This is to certify that Capital, LLC/Capital, LLC/ Greg Shinberg  
has permission to Bayside Medical Office Building/ Garage OCCUPATION ONLY PERMIT  
AT 84 MARGINAL WAY 034A B001001

**Re: 84 Marginal Way, Amended Site Plan**

January 19, 2007

Submitted to:  
Portland Planning Board  
Portland, Maine  
January 9, 2007

Title: OPEN SPACE EXHIBIT  
 BUILDING HEIGHT CALCULATION

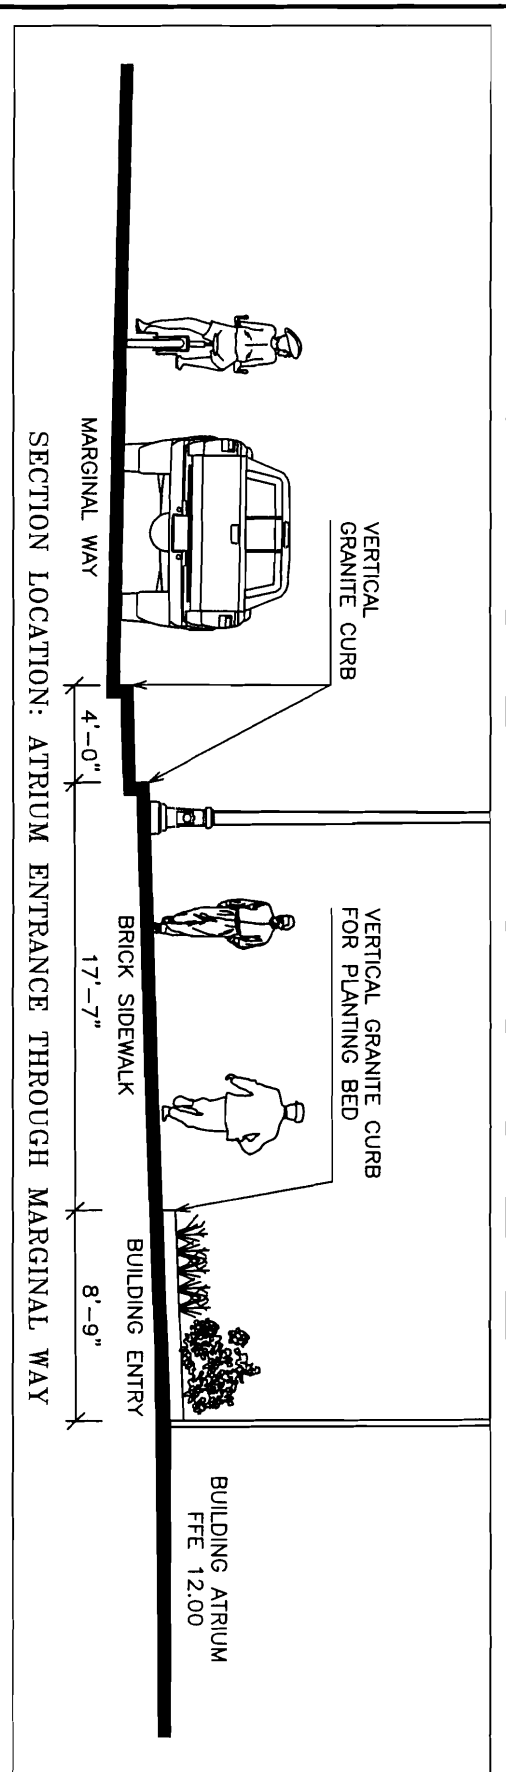
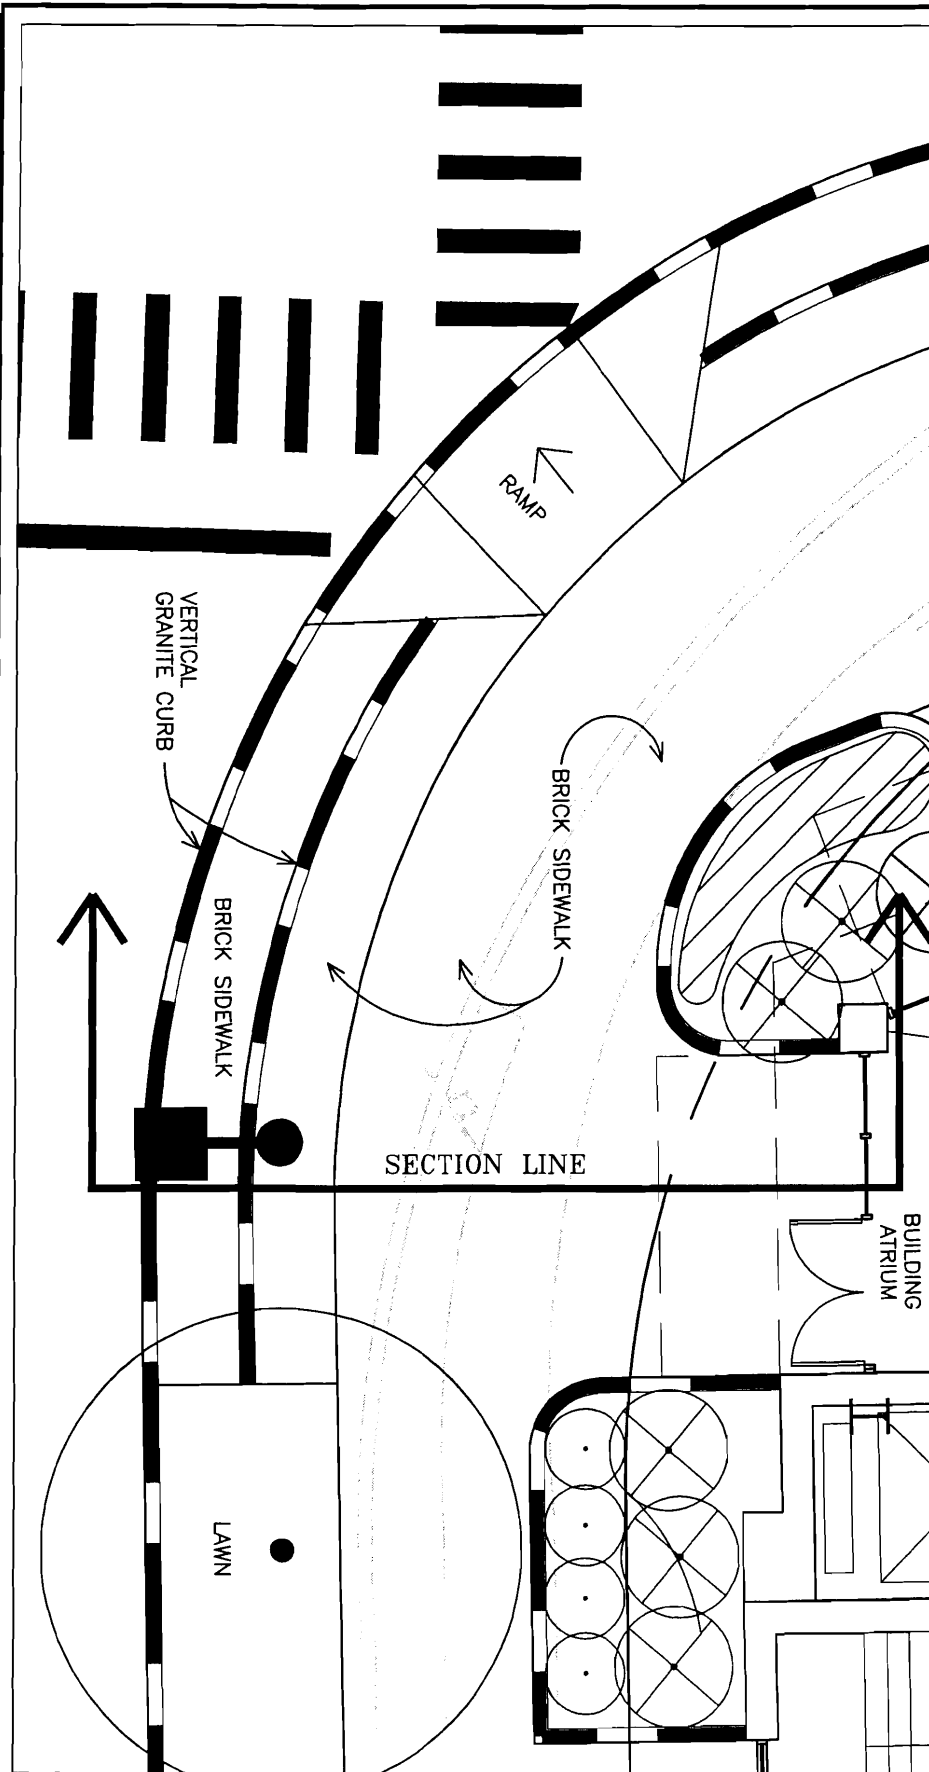
- vii. That a revised plan shall be submitted to the Zoning Administrator for review and approval clearly delineating the property line along Marginal Way and Preble Street and that additional information be provided to confirm the building height.

I would also like to confirm the actual building height. The given information begins measurement at the first floor ground level. The Zoning Ordinance begins measurement at grade, which can be averaged if grade elevations are shown around the building. The other required point for height measurement for flat roof structures is the top of the highest structural beam (excluding elevator and stair towers and other facade materials. I would like a plan with accompanying information to confirm the building height.

**The submitted Amended Site Plan addressed the question regarding the location of the building façade in relationship to the right-of-way/property line. The line weight assigned to the property line on the drawings was revised to clearly delineate the location of the building in relationship to the property line. Regarding the building height, we have reviewed the height issue with Marge Schmuckal as part of the submission for the Amended Site Plan.**
